**United States Steel**  
Minnesota Ore Operations  
Minntac

RE: United States Steel Corporation, Minnesota Ore Operations  
Request to Modify Permits 2012-02481-JCB, 2010-00832-JCB and MBI  
Final Palisade Modifications Plan

**Keetac Expansion Permit 2012-02481-JCB  
Requested Modifications Summary**

**Minntac Progression Permit 2010-00832-JCB**  
**Requested Modifications Summary**

Figure 1b  
WETLAND IMPACTS - EAST  
Keetac Expansion Project  
U. S. Steel  
Keewatin, MN

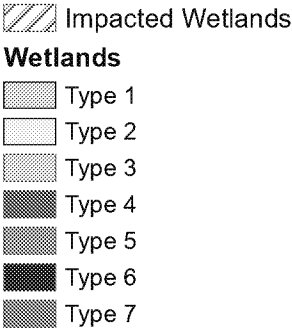
*Direct wetland impacts authorized by this permit are shown in figures 2008-02481-JCB MODIFICATION pages 1 of 9 through 9 of 9, attached to this permit. The total authorized permanent direct impacts to waters of the US for the Keetac Expansion phase II project is **581.79 acres (545.03 acres at the Keetac Mine Site and 36.76 acres at the Palisades I mitigation site)**. The attached map, 2008-02481-JCB MODIFICATION page 1 of 9, shows the Keetac Mine site project area. The authorized work in wetlands and deep water habitat at the Keetac Mine is shown on the attached table and maps labeled 2008-02481-JCB MODIFICATION page 2 of 9 through 8 of 9. The authorized work in wetlands at the Palisades I mitigation site is shown on the attached map labeled 2008- 02481-JCB MODIFICATION page 9 of 9 through 9 of 9.*

Figure 2

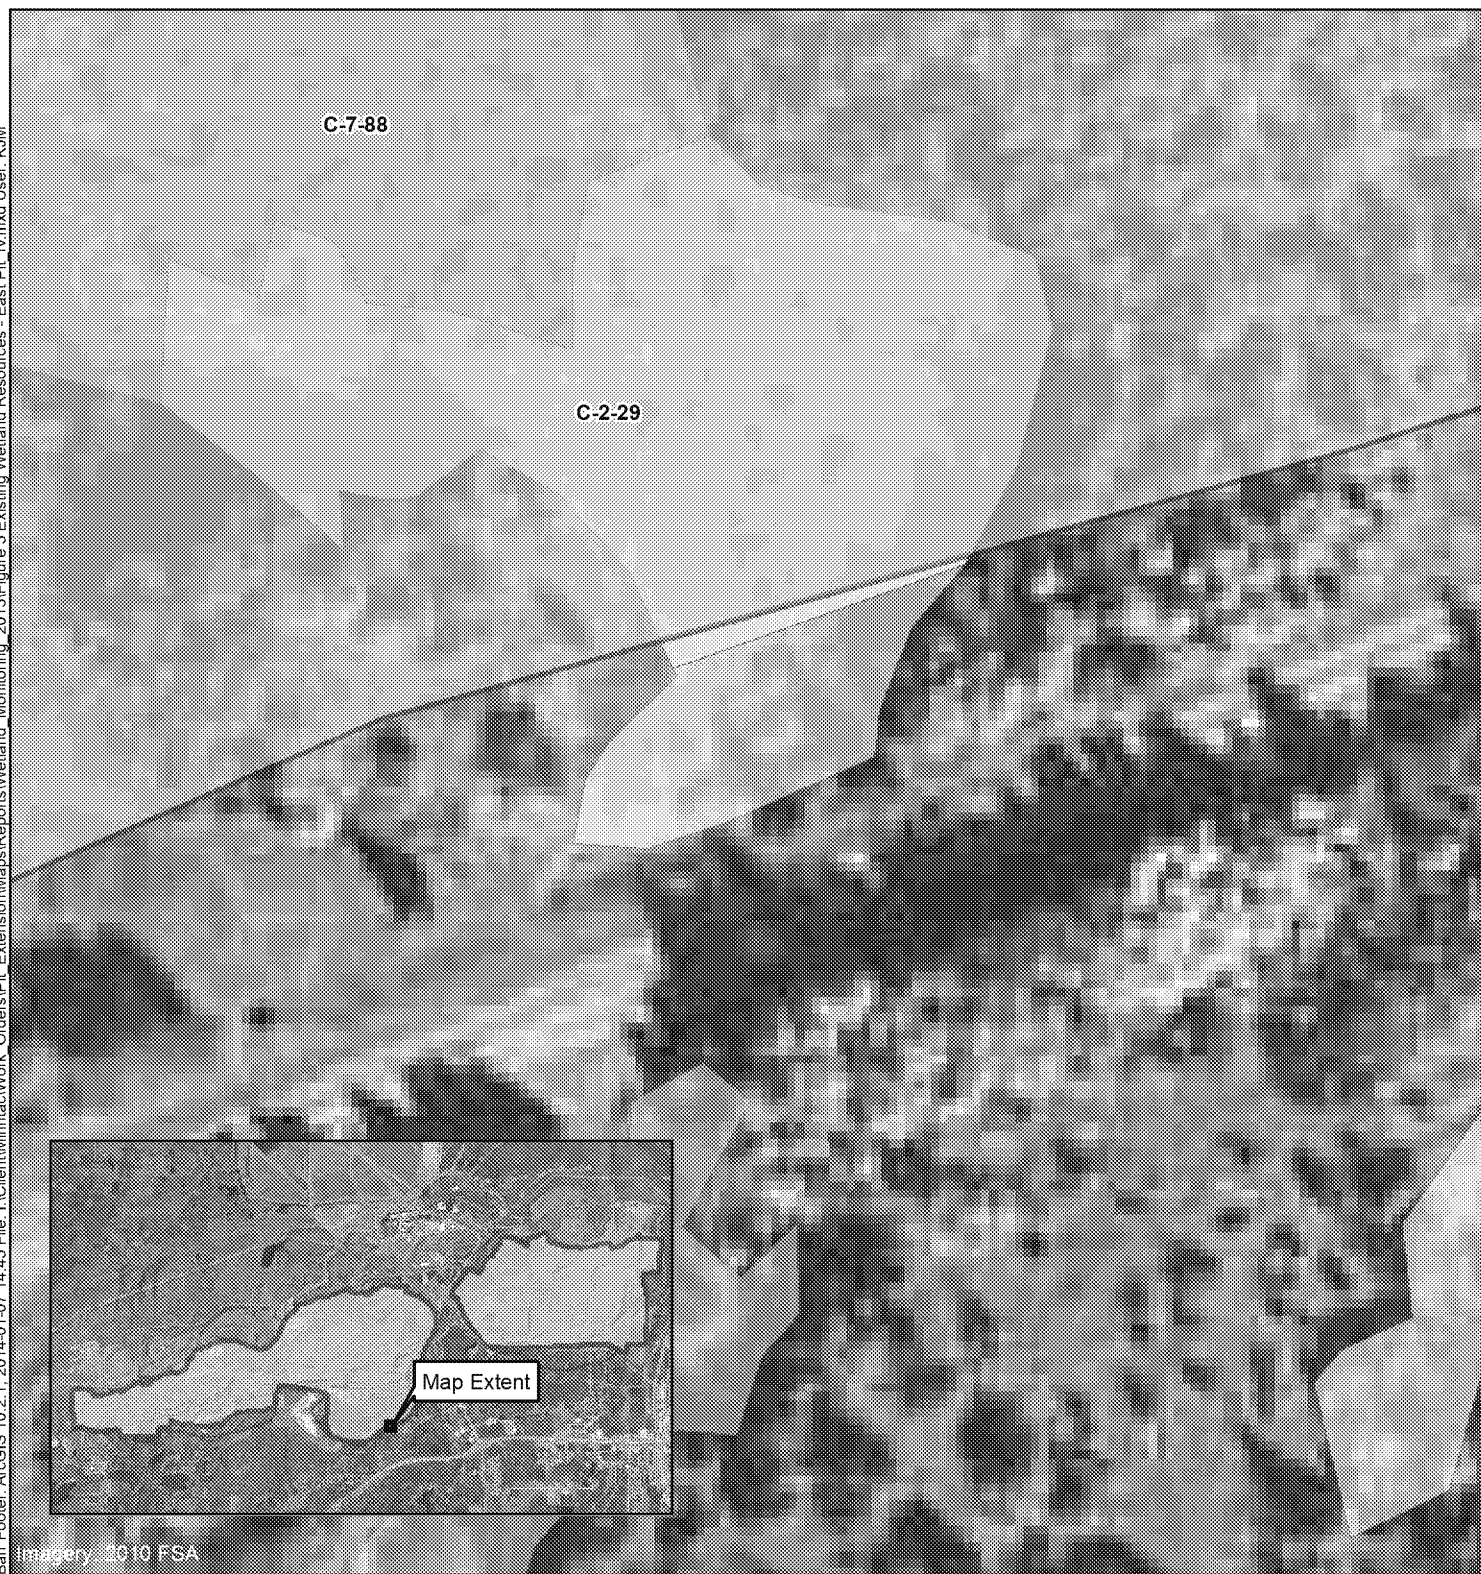
*You are also authorized to permanently impact 1.05 acres of wetlands acres of wetlands for the construction of the No. 6 Sump Dewatering Flow Alternative Process Makeup Water Source Project. Of these authorized impacts, 0.36 acres are located outside of the previously permitted Minntac Extension boundary (2012-00415-JCB) and 0.69 acres are located inside the boundary. These impacts have already been mitigated via the Palisade III Bank Site. You are also authorized to **retain dredged and fill material placed in 5.2 acres of wetlands.***

*In addition, you are authorized to temporarily discharge dredged and fill material into 1.36 acres of wetlands for construction of the No. 6 Sump Dewatering Flow Alternative Process Makeup Water Source Project. Of these authorized impacts, 0. 64 acres are located outside of the previously permitted Minntac Extension boundary (2012-00415-JCB) and 0.75 acres are located inside the boundary. No. 6 Sump wetland impacts are summarized in the table below.*
